## V2500-A5 SERIES PROPULSION SYSTEMS SERVICE BULLETIN

# V2500-ENG-75-0120

AIR – TURBINE COOLING CONTROLLED AIR TUBES – STAGE 10 MAKE UP AIR ADAPTOR WITH  
REVISED MACHINING PROFILE

Remove and Install the High Pressure (HP) Compressor Stage 10 Air Make Up Adaptor  
Figure 1

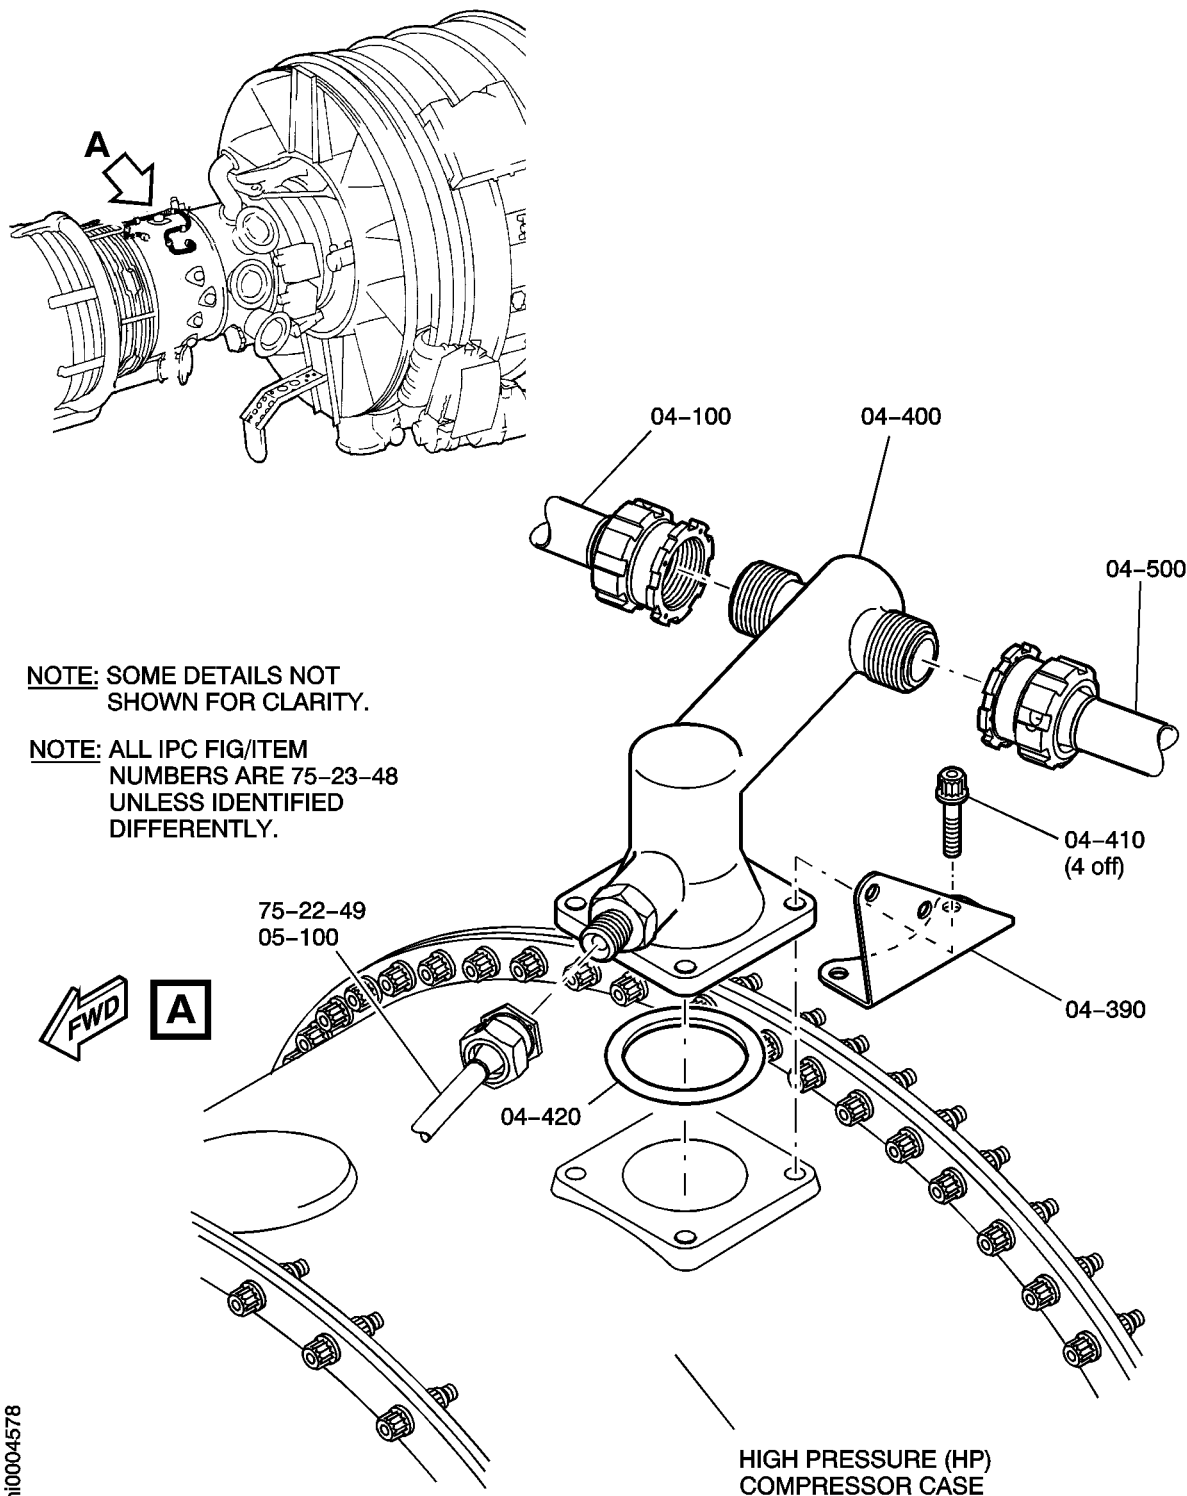
Incorporation of this Service Bulletin introduces a redesigned adaptor with an increased machined recess on the flange which connects the adaptor to the HP compressor case. The increased recess provides additional clearance for the clip bracket mounted on top of the adaptor flange.

An increased machined recess on the flange which connects the adaptor to the HP compressor case. The increased recess provides additional clearance for the clip bracket which is mounted on top of the adaptor flange.

(3) Remove the old HP compressor stage 10 make up air adaptor (75-23-48, 04-400), P/N 6A7555 from the engine.

(4) Install the new HP compressor stage 10 make up air adaptor (75-23-48, 04-400), P/N 6B1429 on the engine.
